State of New Mexico  
Energy, Minerals and Natural Resources

WELL API NO. 30-045-31750
5. Indicate Type of Lease STATE <input type="checkbox"/> FEE <input checked="" type="checkbox"/>
6. State Oil & Gas Lease No.
7. Lease Name or Unit Agreement Name Culpepper Martin
8. Well Number 108
9. OGRID Number 14538
10. Pool name or Wildcat Basin Fruitland Coal
11. Elevation (Show whether DR, RKB, RT, GR, etc.) 5923' GR

SUNDRY NOTICES AND REPORTS ON WELLS  
(DO NOT USE THIS FORM FOR PROPOSALS TO DRILL OR TO DEEPEN, OR PLUG BACK TO A DIFFERENT RESERVOIR. USE "APPLICATION FOR PERMIT" (FORM C-101) FOR SUCH PROPOSALS.)

2. Name of Operator  
Burlington Resources Oil & Gas Company LP

## Drilling Rig Choke Manifold Configuration 3000 psi System

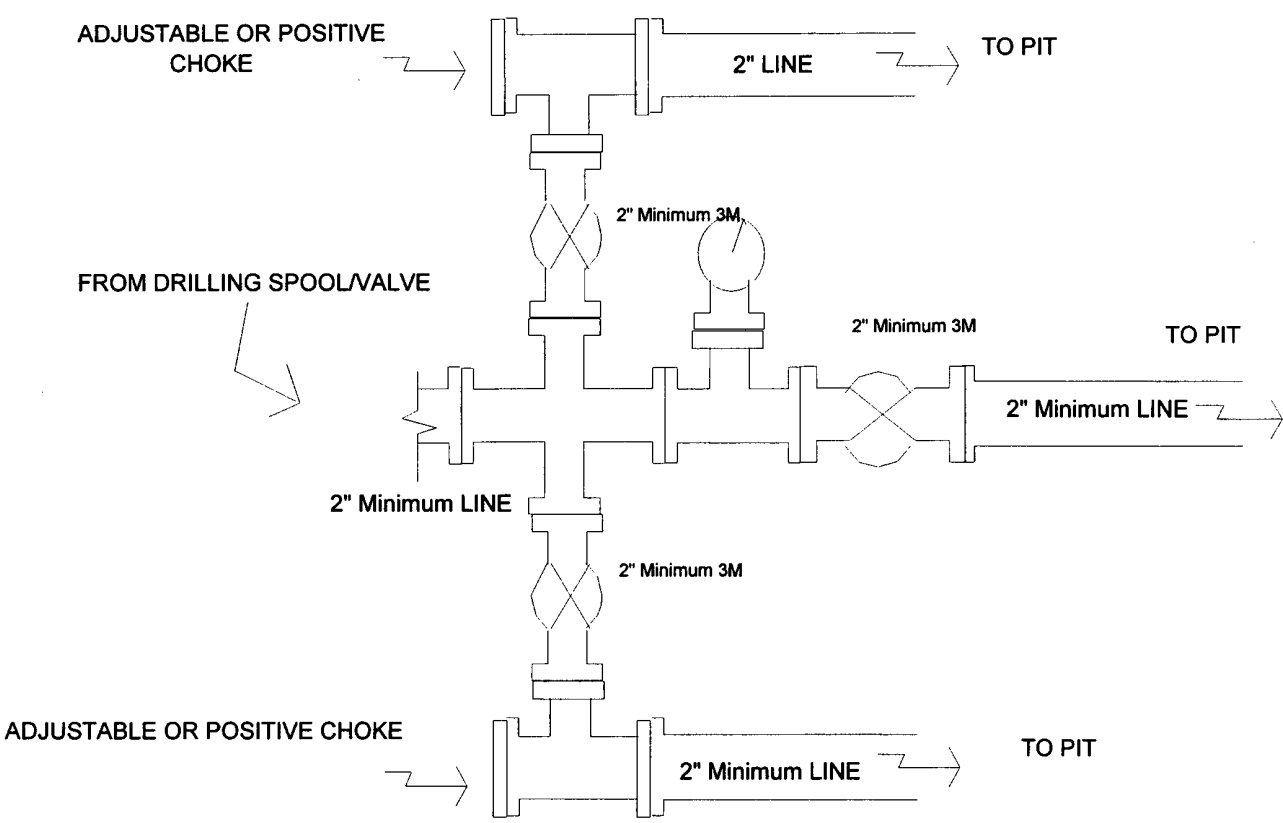
It is intended to revise the approved BOP stack for the subject well. Attached is the new BOP diagram and associated choke manifold diagram. This BOP and choke manifold arrangement will be utilized on a smaller, purpose fit, shallow well drilling rig.

Choke manifold installation from Surface Casing  
Point to Total Depth. 3,000 psi working pressure  
equipment with two chokes.
